ADDENDUM TO THE CONTRACT DOCUMENTS

ADDENDUM No.: 2

DATE : 8/31/15

PROJECT: New Town Hall
Construction Project
26 Court Street
Plymouth, MA

PHASE II: PLYMOUTH TOWN HALL
PLYMOUTH, MA
SECOND FLOOR LIGHTING REVISION
ISSUED FOR: ADDENDUM #2
DATE ISSUED: 08/28/2015
REVISION DATE: 08/28/2015

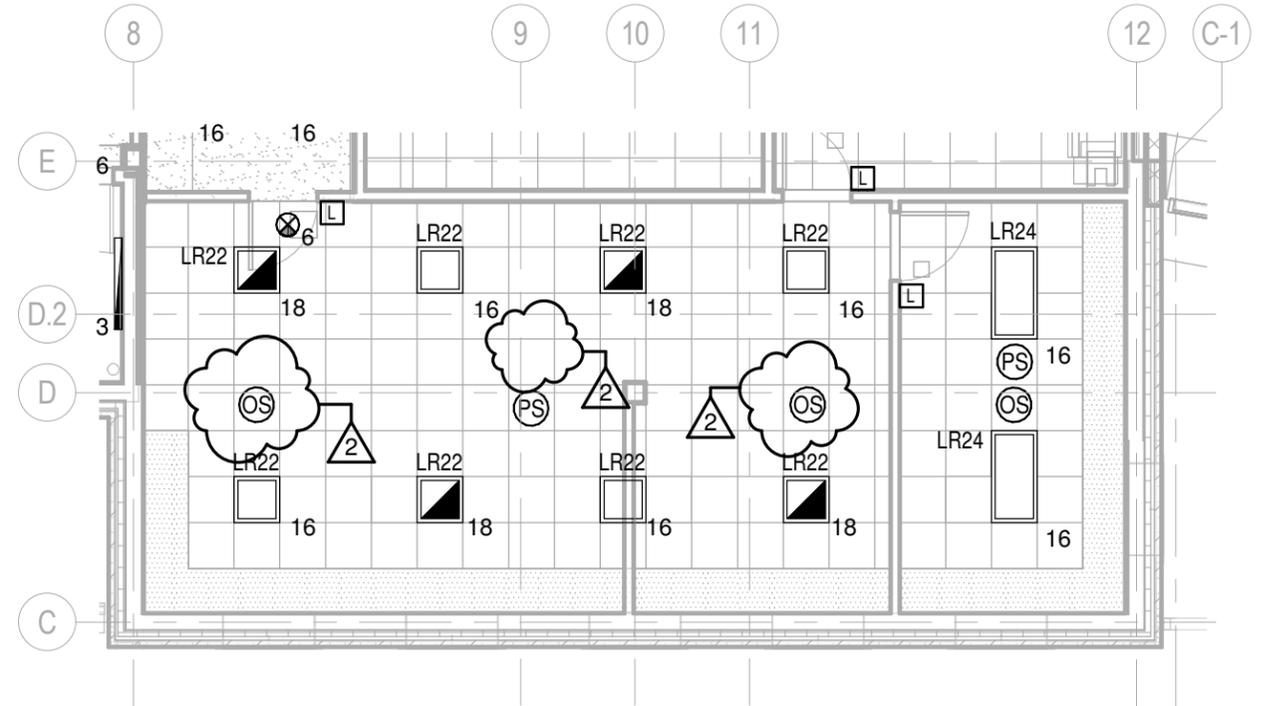
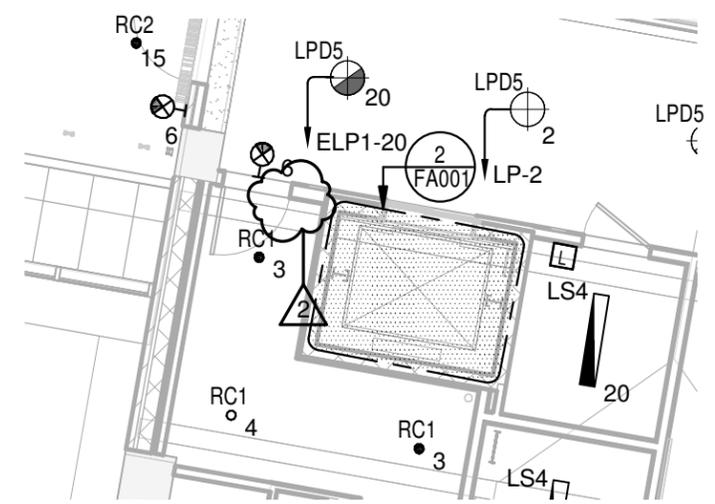
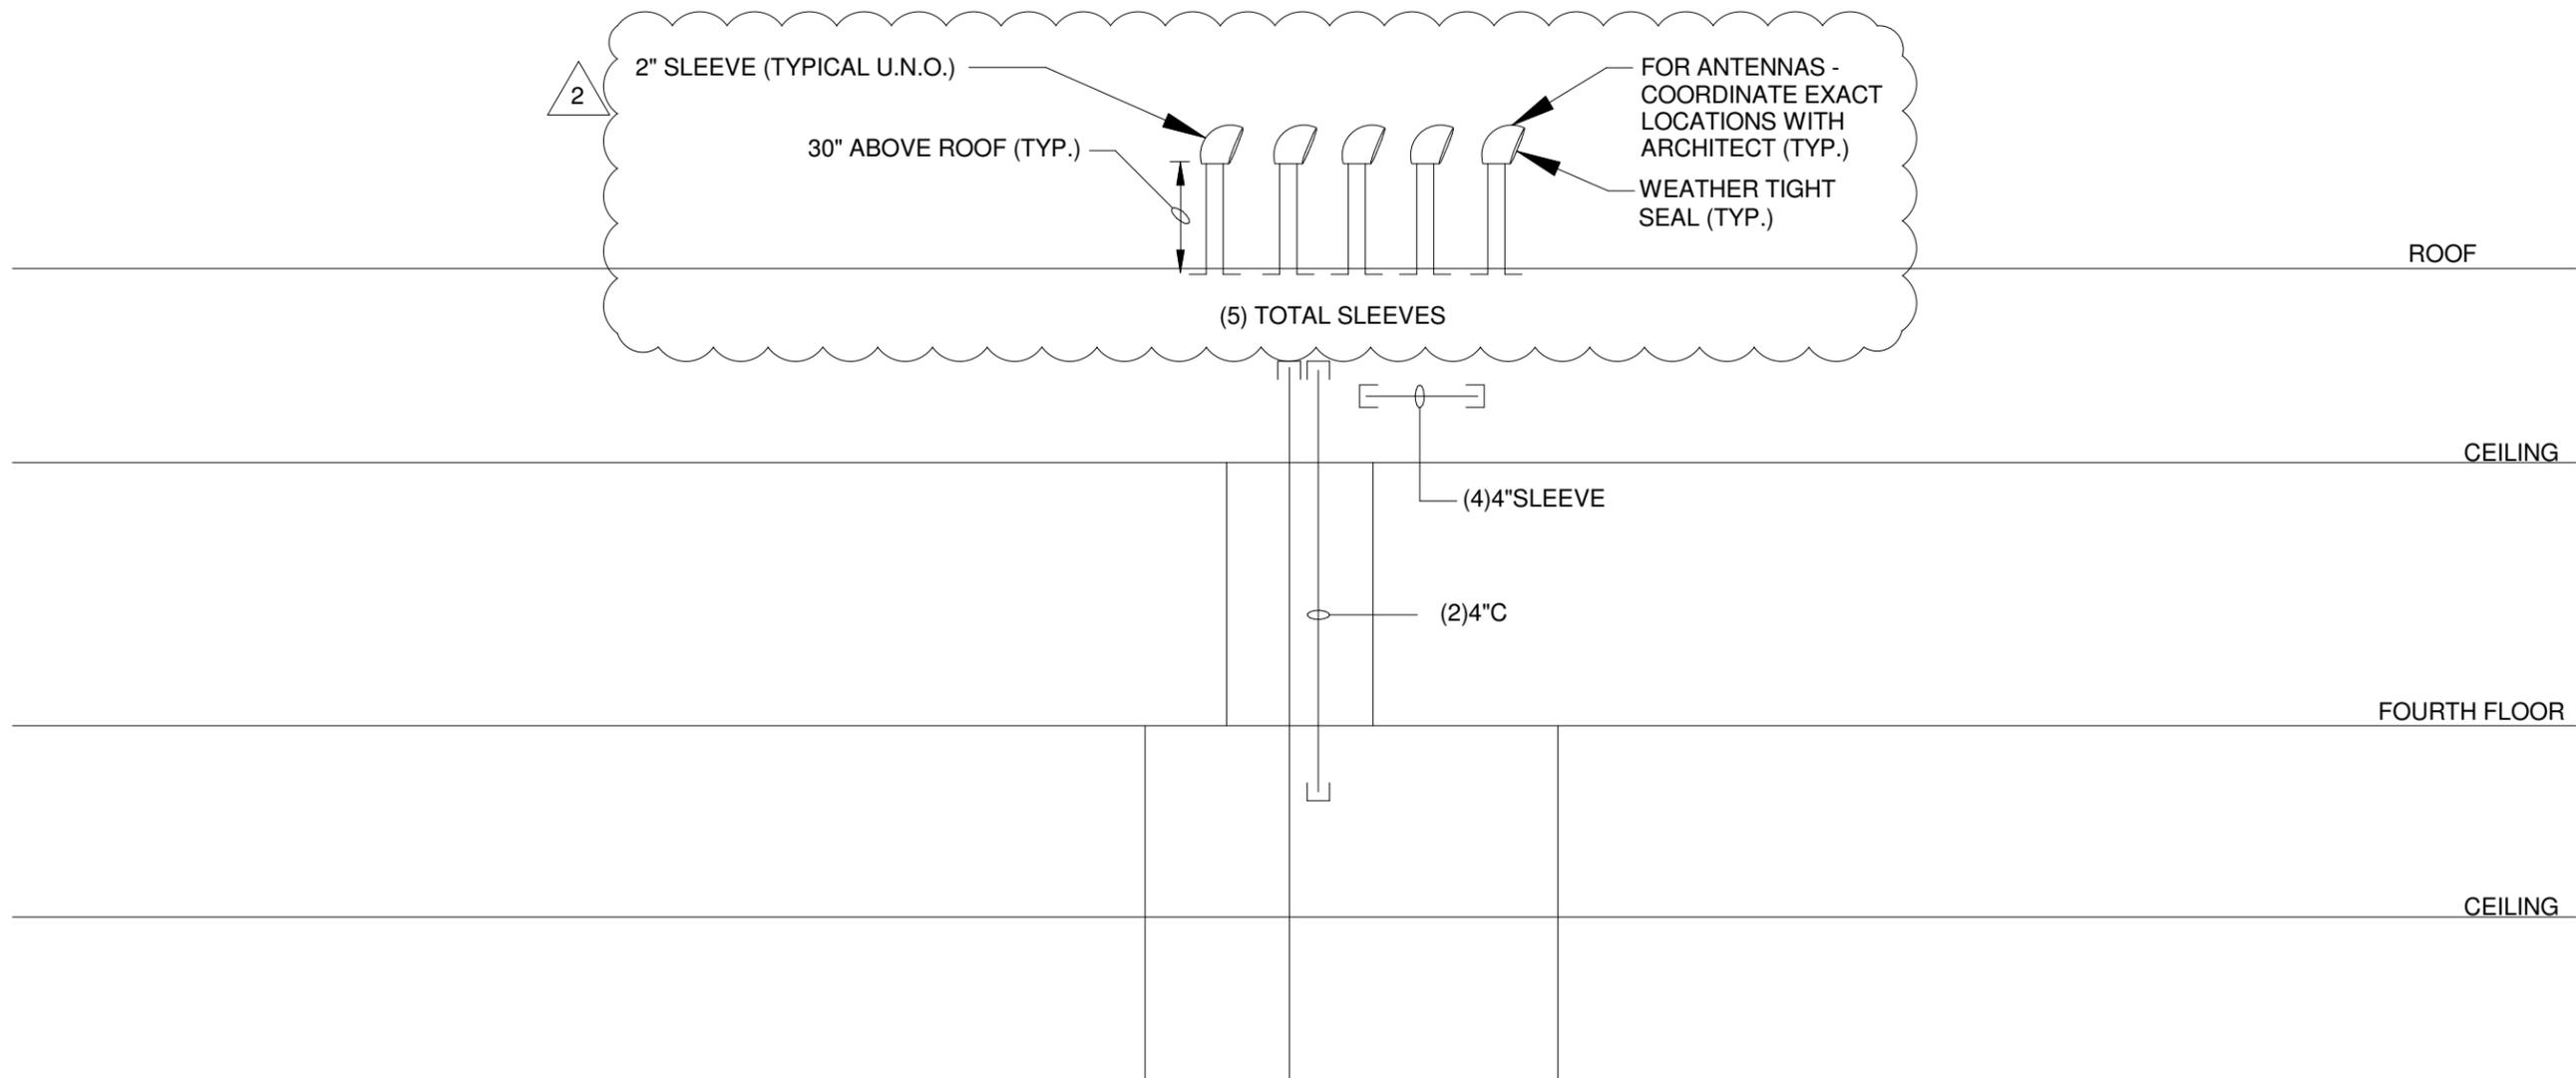
E102	Revise lighting plan, see SKE004.
E103	<ol style="list-style-type: none"> 1. Bidder Question: Fixture symbol "UC" located near the intersection of "K" and "5" doesn't have a corresponding fixture on the plan. Please clarify the length of the fixture. <i>Response:</i> Fixture "UC" runs the length of the cabinet, +/- 20'-0" total (1@6'-0", 1@14'-0"). 2. Revise "UC" and add (1) "LR22" fixture, see SKE002.
E200	Add "ARA" phone, refer to sketch SKE001.
E201	Add "SPR" station, refer to sketch SKE-001.
E202	Add "ARA" phones, refer to sketch SKE001.
E203	Add "ARA" phone, refer to sketch SKE-001.
E204	Add "ARA" phone, refer to sketch SKE-001.
E306	Revise conduit riser and AHU units, see SKE005, SKE007, SKE008, SKE009 & SKE010.
TC001	Add "ARA" phone, refer to sketch SKTC001.
TC100	Add "ARA" phone, refer to sketch SKTC001.
TC101	Add "SRP" station, refer to sketch SKTC001.
TC102	Add "ARA" phone, refer to sketch SKTC001.

PHASE II: PLYMOUTH TOWN HALL
PLYMOUTH, MA
TECHNOLOGY PLAN REVISIONS

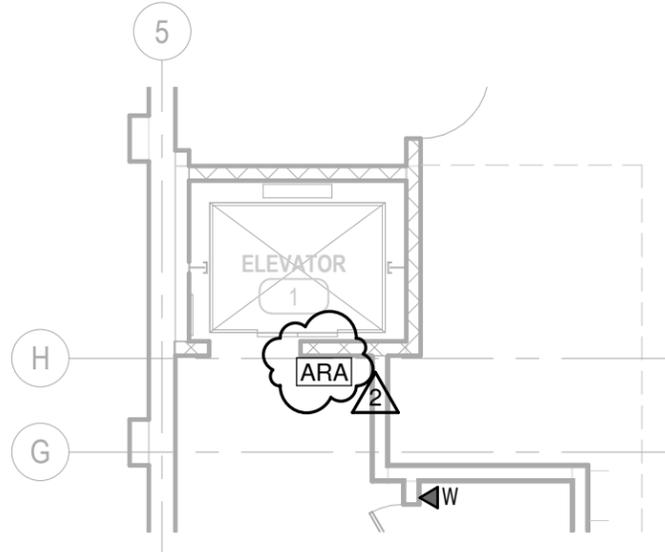
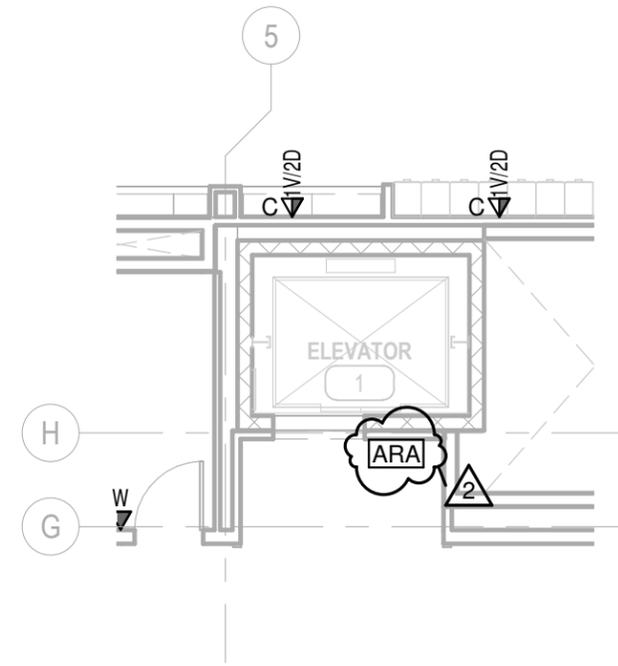
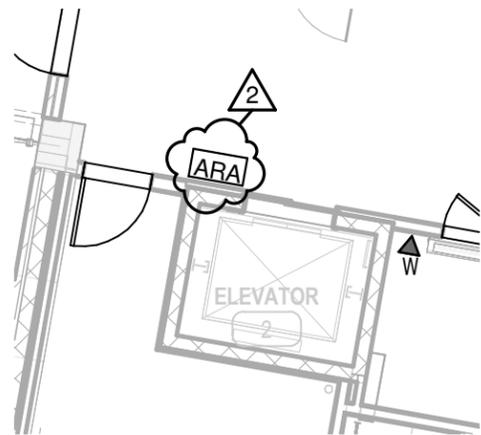
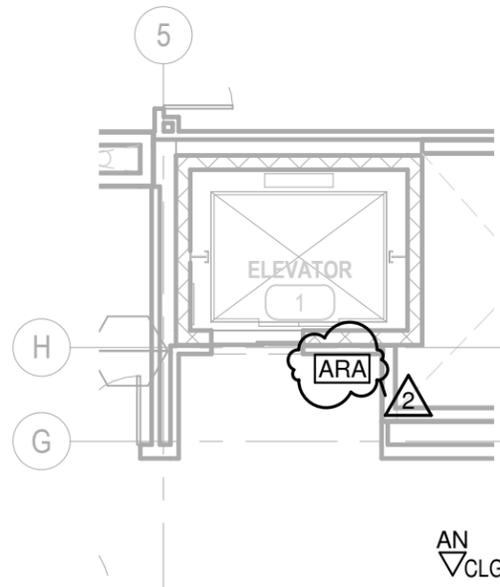
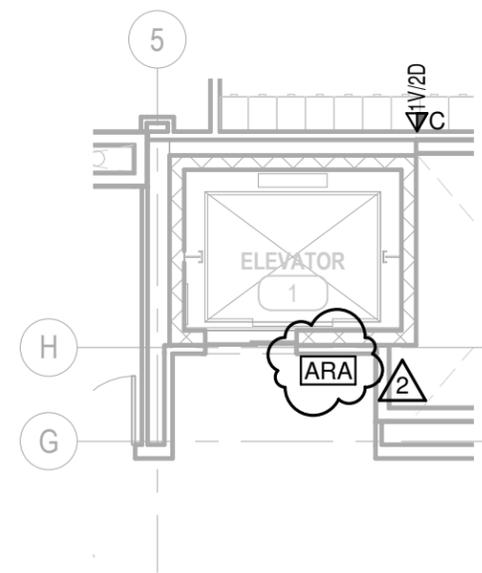
TC103	Add "ARA" phone, refer to sketch SKTC001.
TC104	Add "ARA" phone, refer to sketch SKTC001.
TC300	Add smart rescue base station wiring diagram, refer to sketch SKTC002.
